[Docket No. FAA-2024-0769; Project Identifier AD-2023-00556-T; Amendment 39-22815; AD 2024-16-09]

Airworthiness Directives; The Boeing Company Airplanes

ACTION: Final rule.

Figure 1 to Paragraph (h)(3)—Cap Sealing Dimensions (all Dimensions are in Inches)

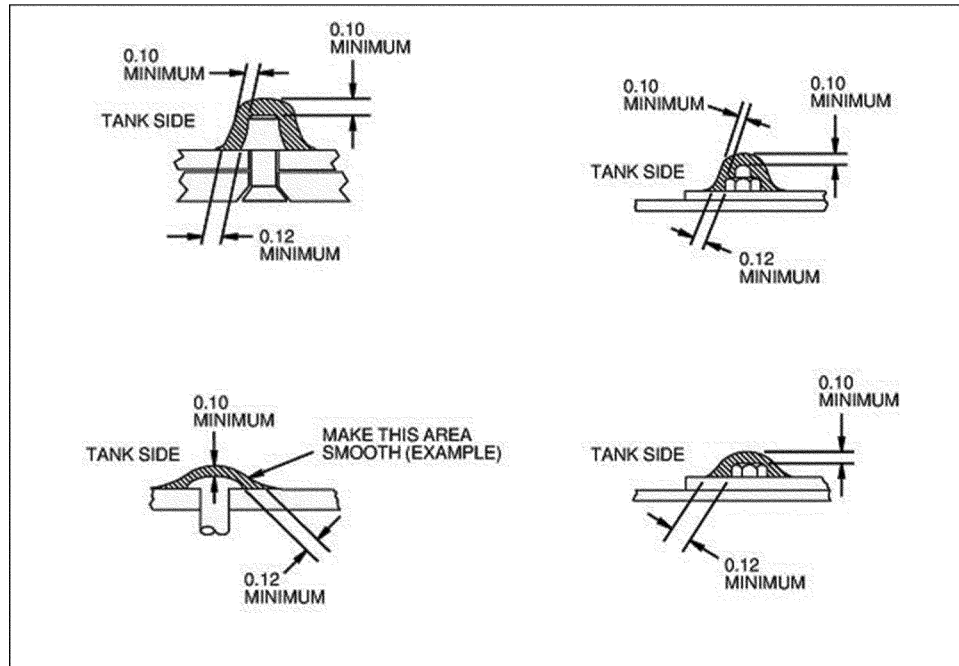
Boeing requested that paragraph (h)(3) of the proposed AD be clarified to specify that only the fuel tank side of fastener locations that penetrate the fuel tank boundary require cap seal dimensions to meet the dimensions given in Figure 1 to paragraph (h)(3) of the proposed AD. Boeing stated that the service information referenced in Boeing Alert Requirements Bulletin 777–53A0100 RB, dated March 16, 2023, contain instructions for applying cap seals to fasteners that penetrate a fuel tank boundary and fasteners that do not penetrate a fuel tank boundary. Boeing added that for fasteners that do not penetrate a fuel tank boundary, fastener sealing is used as a pressure seal to help mitigate corrosion and have sealing specifications that include minimum thickness requirements less than the amount shown in paragraph (h)(3) of the proposed AD that are acceptable for their intended function outside of the fuel tank. Boeing stated that for fasteners that penetrate the fuel tank, the cap seals on the interior side of the fuel tank act as a primary fuel seal, providing fault tolerance against electromagnetic effects (electrical fault currents and lightning currents), and are also cap sealed on the exterior side for corrosion prevention.

Boeing concluded that only the cap seals on the interior side of the fuel tank require the dimensions specified in Figure 1 of paragraph (h)(3) of the proposed AD to perform their intended function, which is consistent with the labels shown in Figure 1 of paragraph (h)(3) of the proposed AD. Boeing recommended replacing the text “applying a cap seal (sealant) to a fastener, fastener head, and fastener threads and collars, for this AD, during application of any cap seal to a fastener, fastener head, or fastener threads and collars” with the text “applying a cap seal (sealant) to a fastener location that penetrates the fuel tank boundary, for

this AD, during application of any cap seal to a fastener, fastener head, or fastener threads and collars inside the fuel tank.”

Boeing requested that the FAA add a note to paragraph (h)(3) of the proposed AD to refer to Boeing Model 777 Aircraft Maintenance Manual (AMM) section 28–11–00 as an acceptable cap sealing procedure to accomplish the actions required in that paragraph. Boeing stated it has received numerous queries from operators on Figure 1 to paragraph (h)(4) of AD 2023–17–14, which is identical to Figure 1 to paragraph (h)(3)

of the proposed AD. Operators have asked whether Boeing Model 777 AMM section 28–11–00 would be an acceptable procedure for accomplishing the requirements of paragraph (h)(4) of AD 2023–17–14. Boeing stated it believes that AMM 28–11–00 is an acceptable procedure for performing cap sealing inside the fuel tank because the AMM is the source material for the contents in Figure 1 to paragraph (h)(3) of the proposed AD and contains the same minimum seal thickness dimensions as shown in Figure 1.

The FAA agrees to clarify paragraph (h)(3) of this AD for the reasons provided by the commenter. Locations that do not penetrate the fuel tank boundary do not require the same sealant application procedures. The FAA has added the text “inside the fuel tank” to paragraph (h)(3) of this AD. However, the FAA did not replace the text “to a fastener, fastener head, and fastener threads and collars” with the text “to a fastener location that penetrates the fuel tank boundary,” as recommended by the commenter, because the text “to a fastener, fastener head, and fastener threads and collars inside the fuel tank” better aligns with the language within the service information.

The FAA agrees. Boeing 777 AMM 28–11–00 meets the sealant requirements of Figure 1 to paragraph (h)(3) of this AD. As such, it would be an acceptable procedure to follow when sealing inside the fuel tank in accordance with paragraph (h)(3) of this AD. The FAA has added a note to paragraph (h)(3) of this AD accordingly.

(3) Where any service information referenced in Boeing Alert Requirements Bulletin 777–53A0100 RB, dated March 16, 2023, specifies applying a cap seal (sealant) to a fastener, fastener head, and fastener threads and collars inside the fuel tank, for this AD, during application of any cap seal to a fastener, fastener head, or fastener threads and collars inside the fuel tank, the cap seal must be applied using a cap sealing procedure with thickness greater than or equal to the dimensions given in Figure 1 to paragraph (h)(3) of this AD.

Note 4 to paragraph (h)(3): Guidance on an acceptable cap sealing procedure for accomplishing the actions required by paragraph (h)(3) of this AD can be found in Boeing Model 777 Aircraft Maintenance Manual (AMM) section 28–11–00.
